merCruiser
STERN DRIVES & INBOARDS

service bulletin

No. 89-27

4.3LX and 5.7L Choke Rod Linkage

Figure 1

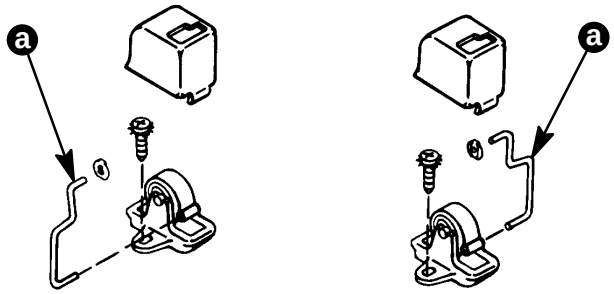
The list of serial numbers following are engines having a incorrect installation of the choke rod linkage. The linkage is installed in reverse of normal installation. Figure 1

The engine may experience a hard start or a rich running condition.

When servicing these engines inspect the choke linkage for proper installation.

Figure 2

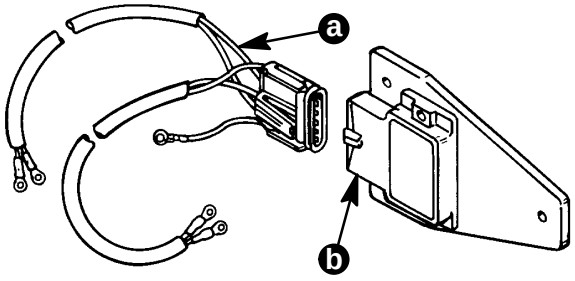
This problem only affects the type of HEI Amplifier and its wiring harness as shown below in Figure 2.

If you experience an engine back-fire or mis-fire above 3000 RPM (especially when activating an electrical accessory such as the power trim or the boats trim tabs), check the wire going to the plug-in connector terminal(s). On some units the WHT/RED and PUR wire is cross wired at the connector. Refer to Figure 3 for correct wiring.

Figure 4

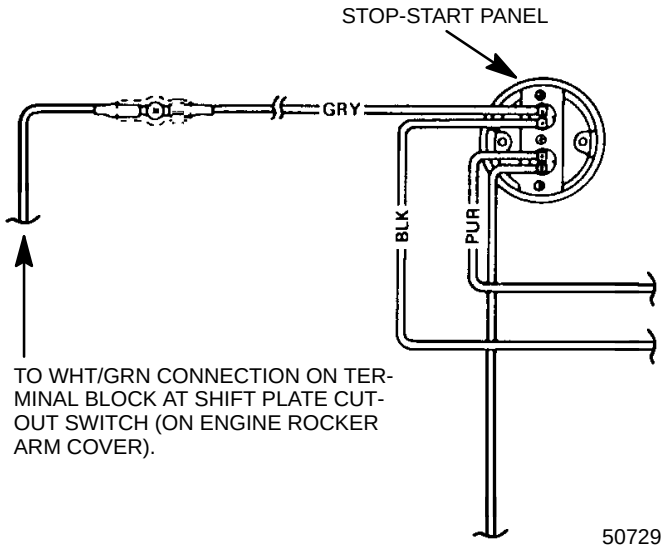
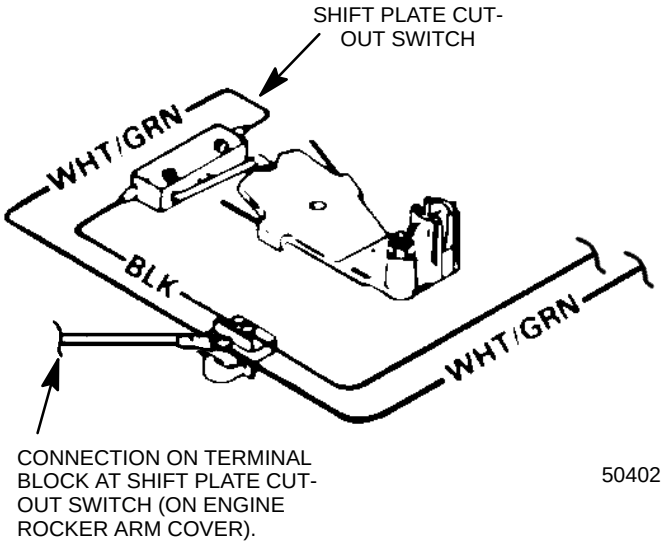
Because of the different wiring configurations between the D.D.I.S. Ignition and the Conventional ignition Systems the above mention kit must be wired as shown (Figure 4 and 5) when being used on the D.D.I.S. System.

A separate 16 gauge wire (not supplied) must be attached outside the wire harness from the stop button back to the shift plate cut out switch on the engine.

Connecting the kit using the Conventional Ignition procedure will not allow the D.D.I.S. Ignition engine to stop.
